ON-SITE SEWAGE DISPOSAL SYSTEM HOWARD COUNTY HEALTH DEPARTMENT BUREAU OF ENVIRONMENTAL HEALTH

SUBDIVISION: Brighton Pines LOT NUMBER: 11

ADDRESS: 13773 Lakeside Drive PROPERTY OWNER: Byron Simms

SITE PLAN
 LOT 11 BRIGHTON PINES
 TAX MAP 34, BLOCK 7, PARCEL NO. 396; LIBER 1331 FOLIO 673
 5th ELECTION DISTRICT, HOWARD COUNTY, MARYLAND

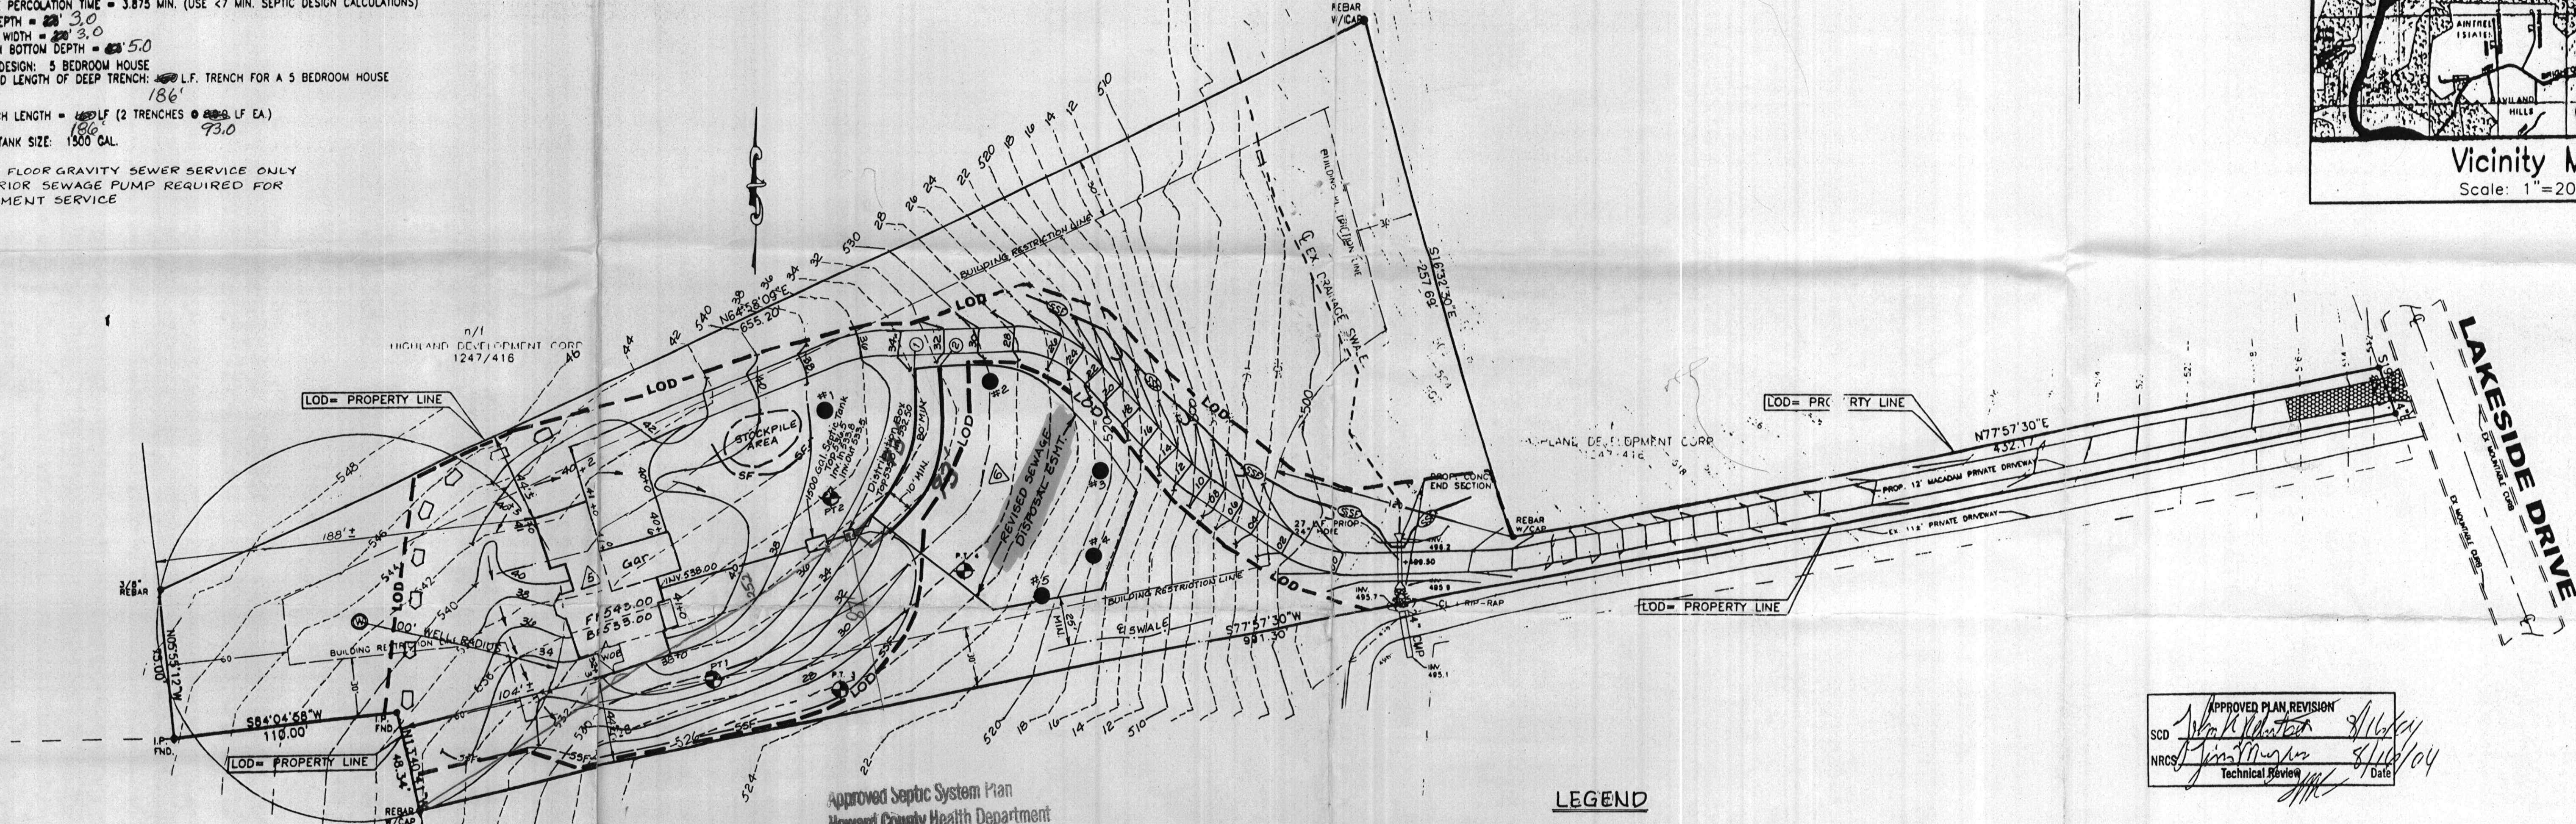
TRENCHES: <u>5.0'</u>	Trench to be 2.0 feet wide. Inlet 2.5 feet below original grade. Bottom maximum depth 2.05 feet below original grade. Effective area begins at 2.5 feet below original grade. 3.0 feet of stone below distribution pipe. <u>3.0'</u>
LOCATION: <u>2.0'</u>	Place the distribution box approximately 50 feet from the highest corner easement stake (as shown on the site plan). Run trenches on contour in both directions.
NOTES:	<i>House foundation poured 19' from SDA. Ensure trench ends no closer than 20" to house.</i>

PRE-CONSTRUCTION 3/9/05 Fill placed over more than half of septic easement. To issue stop work order until fill is removed and a new grading plan is submitted along with a letter from the builder saying that fill will not be put back over area. Or a suitable alternative is agreed upon. Relayed message to septic installer. (BB) 3/11/05 - Met w/ Builder, his plan a different than ours, his does show some grading but not as much as done. He agreed to remove the fill and/or submit corrected plans (SO)
